**PD Modification Application: PRS 21-1114**

**Introduction Summary:**

PD 19-0549 was approved in 2019 to allow for 58 single-family attached (townhome) residential dwelling units. The applicant requests a modification to the approved zoning condition number 1, to reduce the minimum lot width from 22 feet to 20 feet.

8.2 Proposed Site Plan (Full)

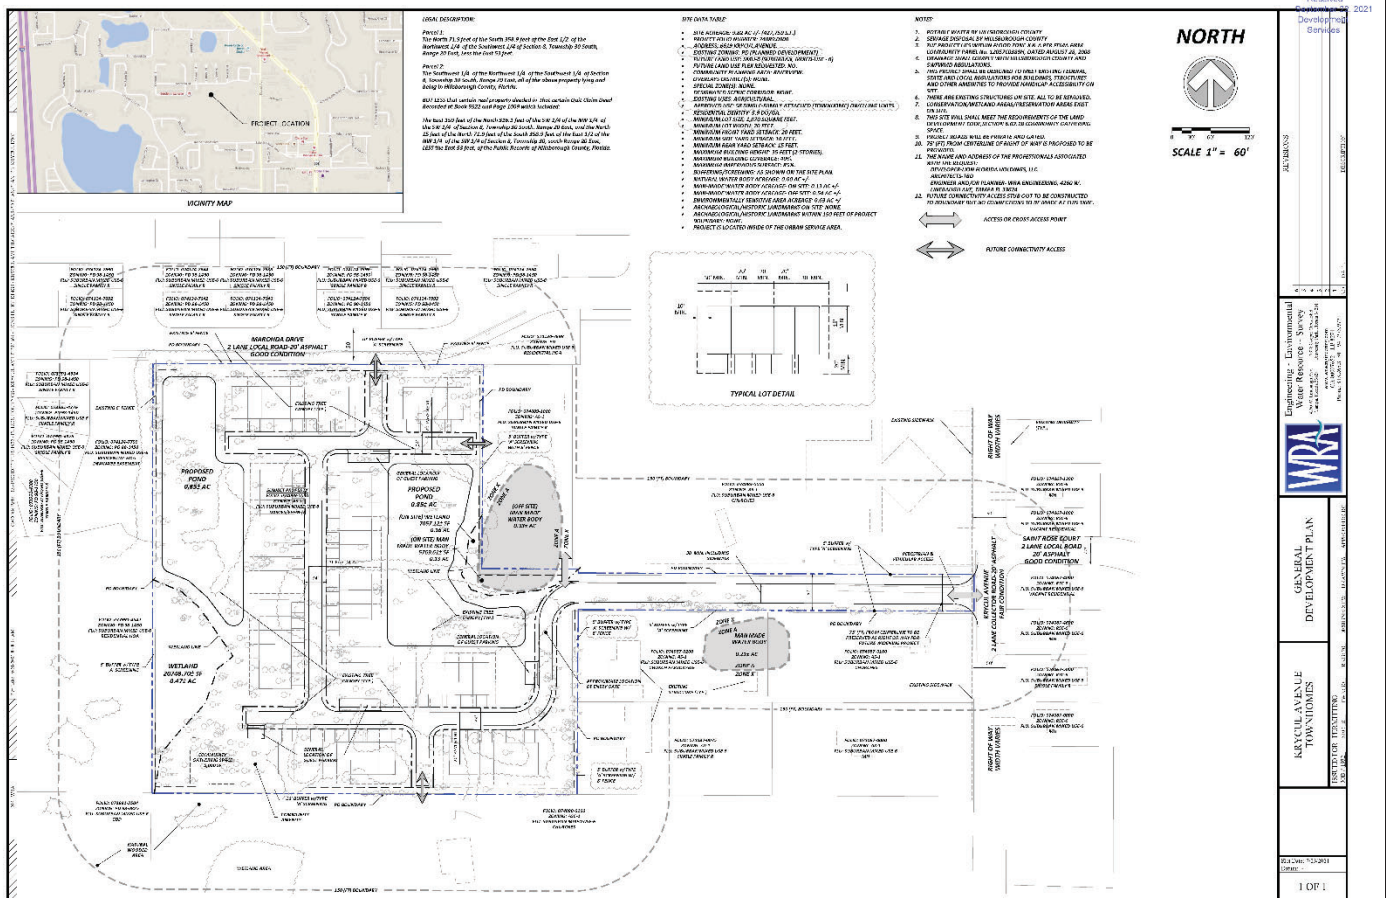
Based on the adjacent zonings and uses identified above in the report, staff finds the proposed modification to PD 19-0549 compatible with the existing zoning districts and development pattern in the area. As Townhomes are single-family attached units with property lines, the 2-foot reduction in the minimum lot width will have a minimal impact, if any, on the overall size of the townhome structures. The number of townhome units per building remains the same on the revised general site plan when compared to the existing general site plan.

Minimum Lot Size:	1,870 Square Feet
Minimum Lot Width:	<del>220</del> Feet
Front Yard Setback:	20 feet
Side Yard Setback:	10 feet
Rear Yard Setback:	15 feet
Maximum Building Height:	35 feet (Maximum 2-Stories)
Maximum Building Coverage:	40%
Maximum Impervious Surface:	85%
